CITY OF ALBUQUERQUE

RE: **GAHP Silver Downtown**
800 Silver SW
Grading Plan Engineer's Stamp Date: 1/30/2017
Hydrology File: K13D013

Based upon the information provided in your submittal received 2/10/17, the Grading Plan is not approved for Building Permit. The following comments need to be addressed for approval of the above referenced project:

CONCEPTUAL
GRADING
PLAN

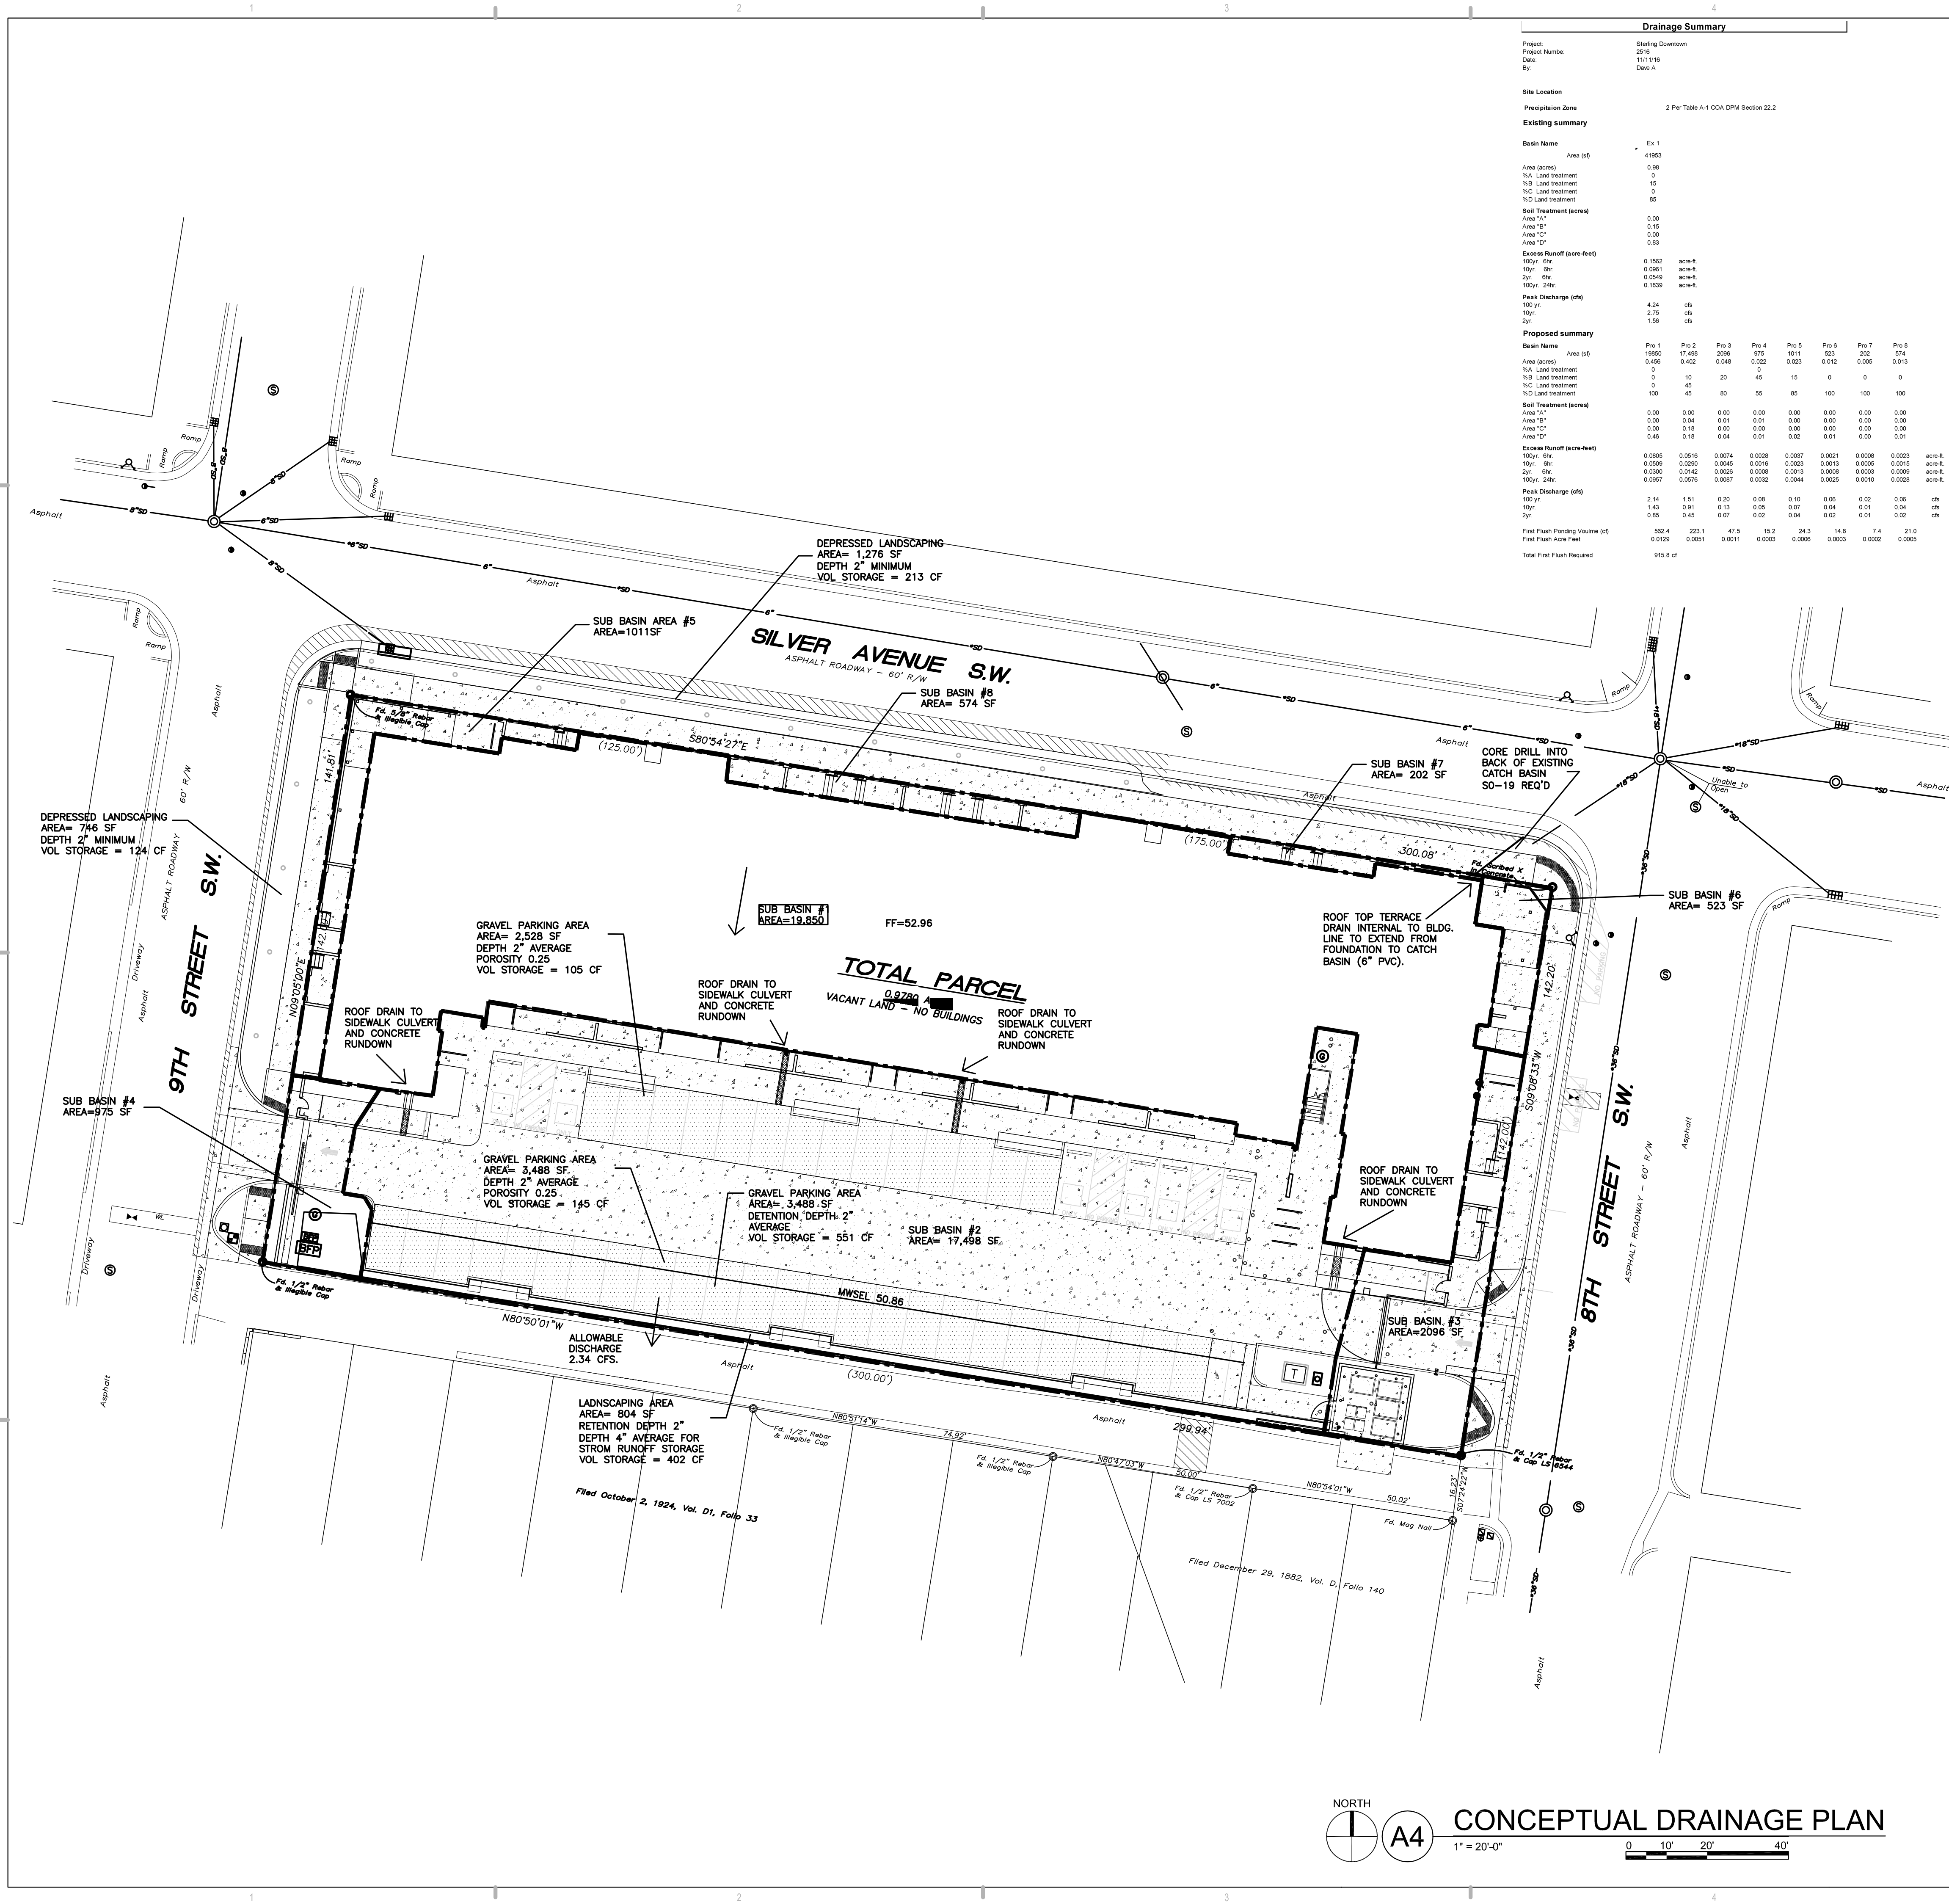
1. The drainage sheets still state conceptual and do not appear to be part of the construction plans. Remove conceptual references to include as part of the submittal.

A4 OVERALL GRADING PLAN
1" = 20'-0"

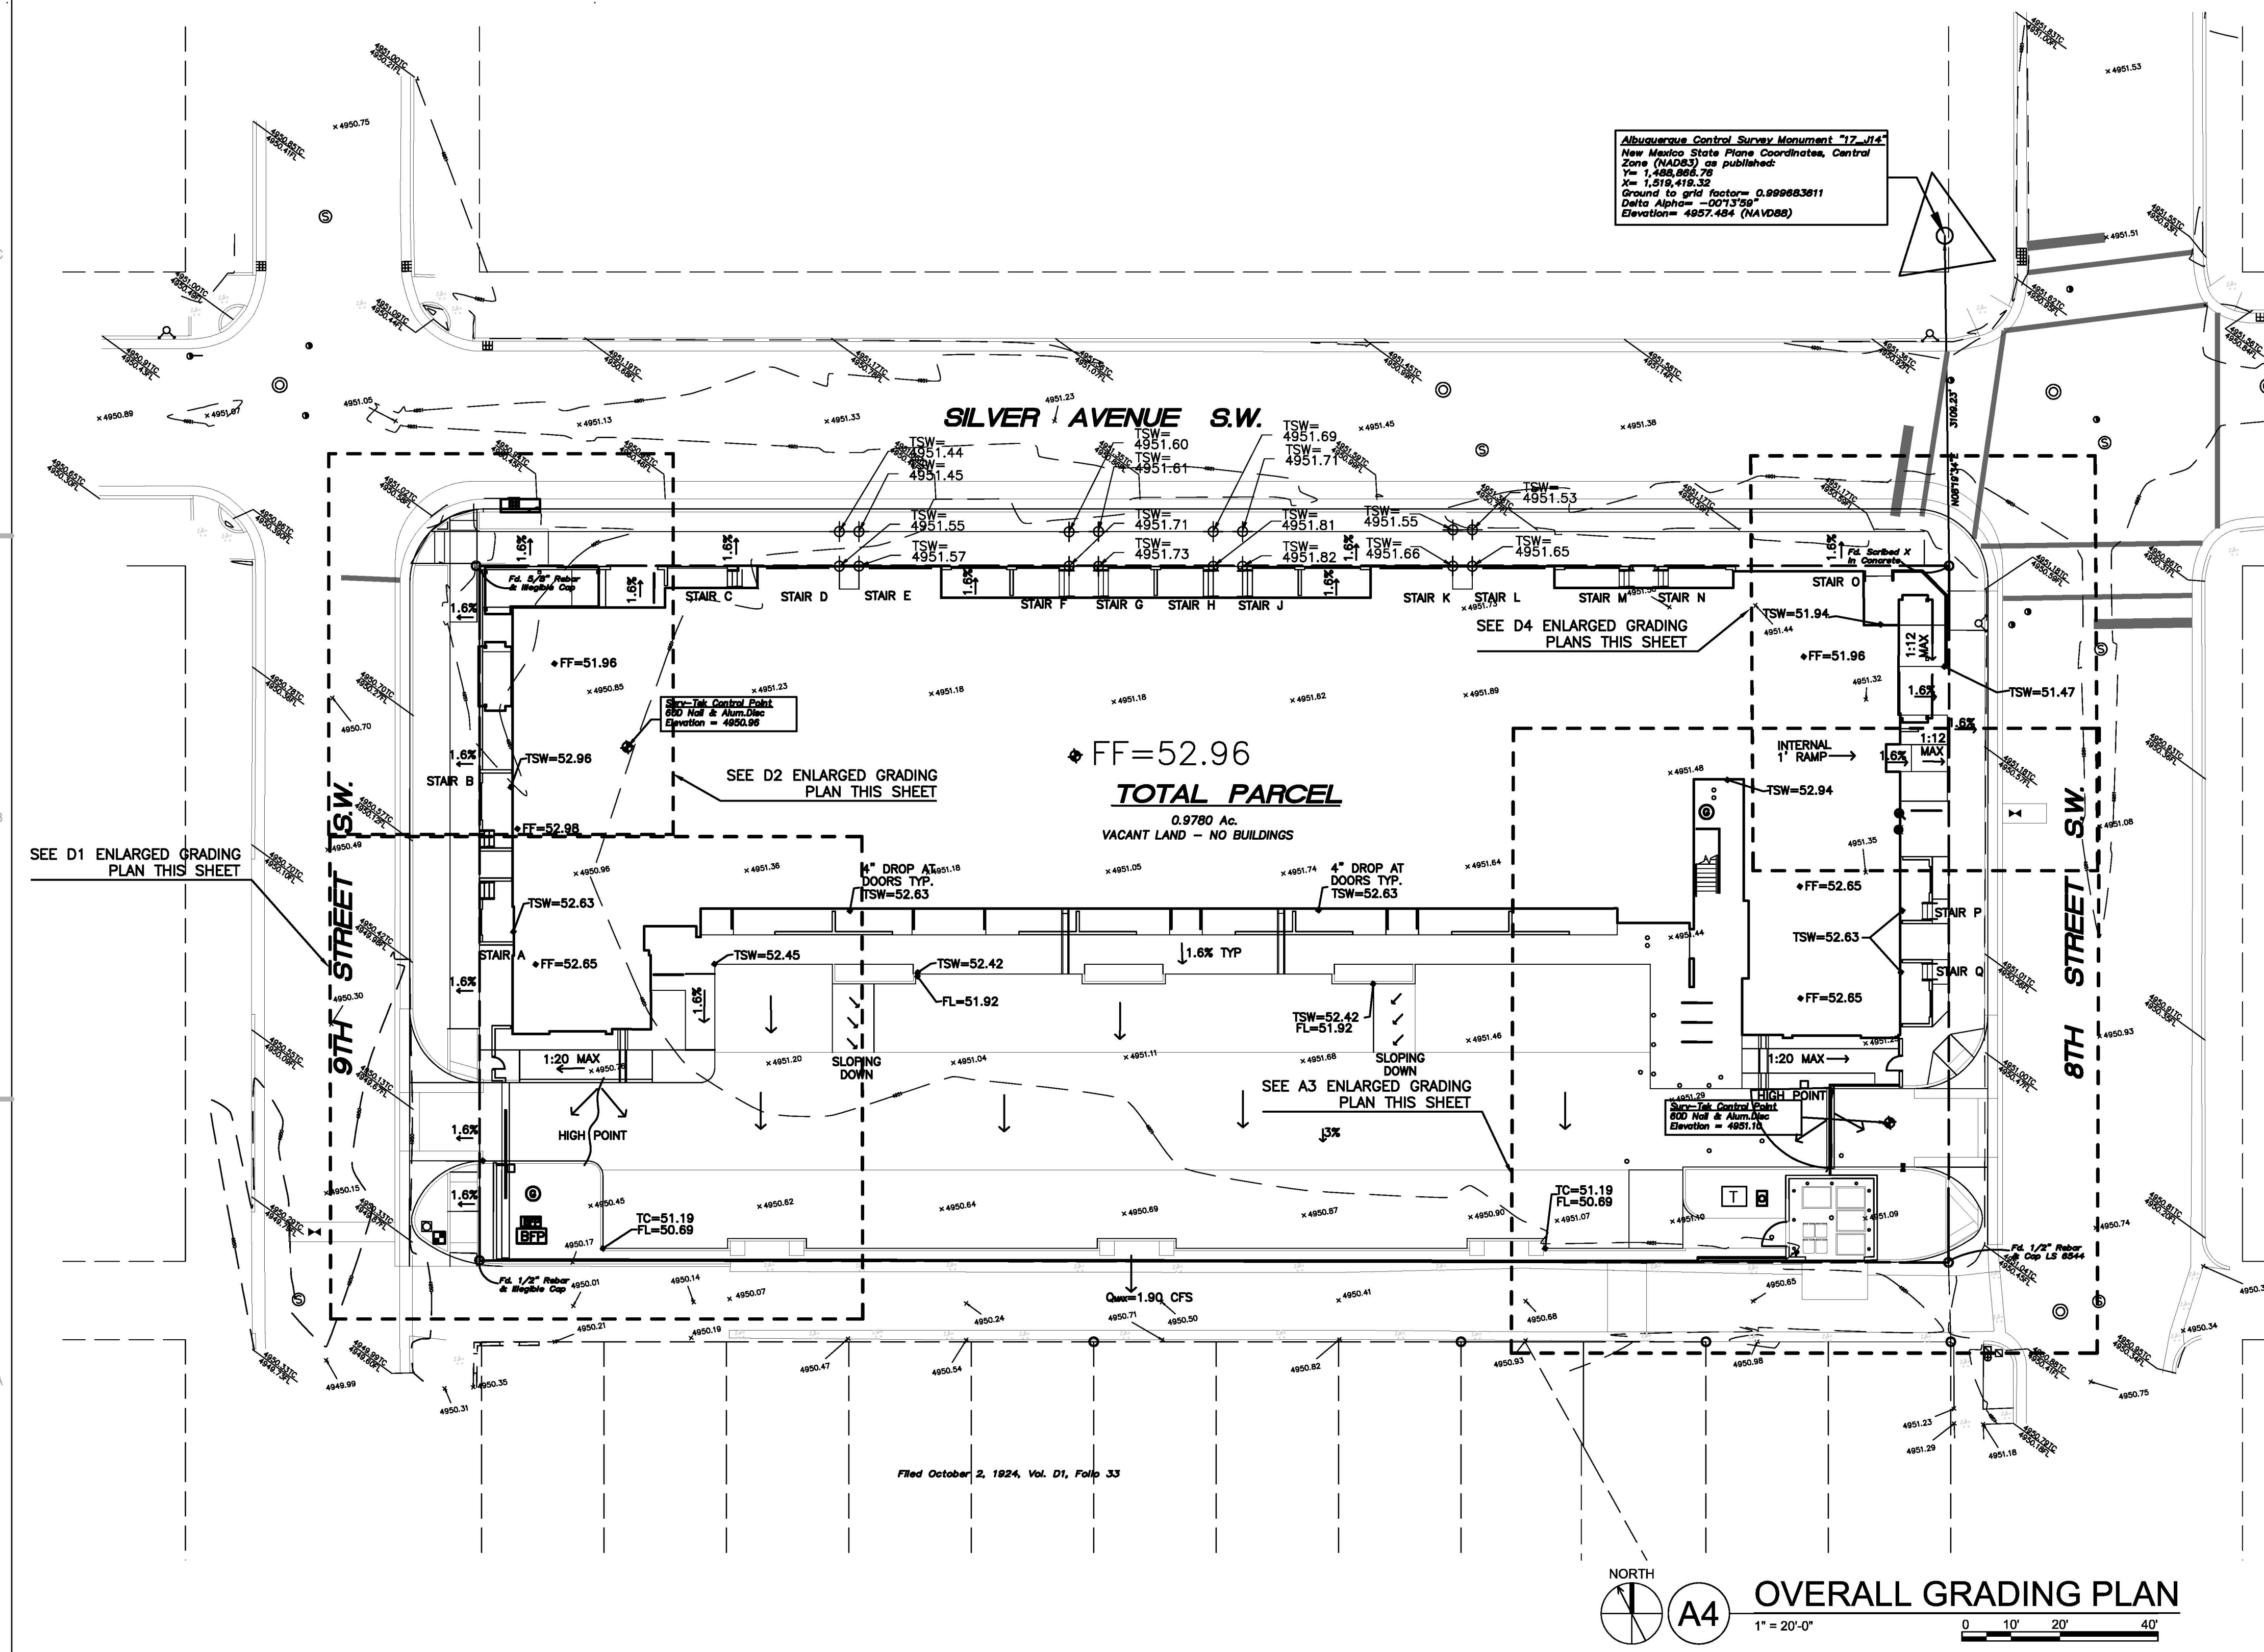
3. There is a reference to a constrictor plate for the draining the parking lot to the ally, but none is shown on the construction plans. Provide location and details for this.

4. It was agreed during the review for SPBP that the wide buffer between the back of curb and the edge of sidewalk would be used to help mitigate nuisance ponding on Silver and 9th Street, by including new curb cuts on the ex. curb. This would help the site achieve the capture of the first flush volume. It needs to be shown on the plan.

5. The 2" depression in the sidewalk buffer does not account for the running slope along top of curb and along the sidewalk. This means the depression will not retain a uniform 2" deep pool. This area needs to be supplemented with a 5:1 gravel filled swale and curb cuts with shallow ponding to allow in flows from Silver and 9th Street.

6. The ponding volume for the parking area does not account for the running slope across the parking lot toward the ally. This means the gravel areas will not retain a uniformly deep 2" of water.
